UNITED STATES PATENT AND TRADEMARK OFFICE

APPLICATION NO.	FILING DATE	FIRST NAMED INVENTOR	ATTORNEY DOCKET NO.	CONFIRMATION NO.
09/935,352	08/21/2001	Larry A. Coldren	510015-269	9440

Office Action Summary

DETAILED ACTION

FIG. 8

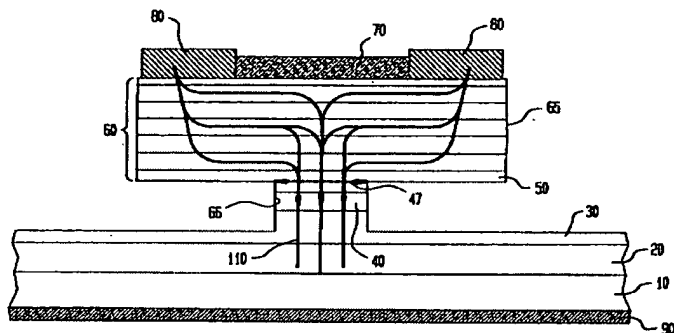
12. Claims 1, 4-16, 18-19, 22, 24-27, 29, 31-32, 35-42, 44, 47-66 are rejected under 35 U.S.C. 102(b) as being anticipated by Jewell et al (5,245,622). Jewell discloses the claimed invention. Note figures 8, 10 which shows an aperture of a VCSEL formed by

selective etching (see col. 8 lines 32-55).
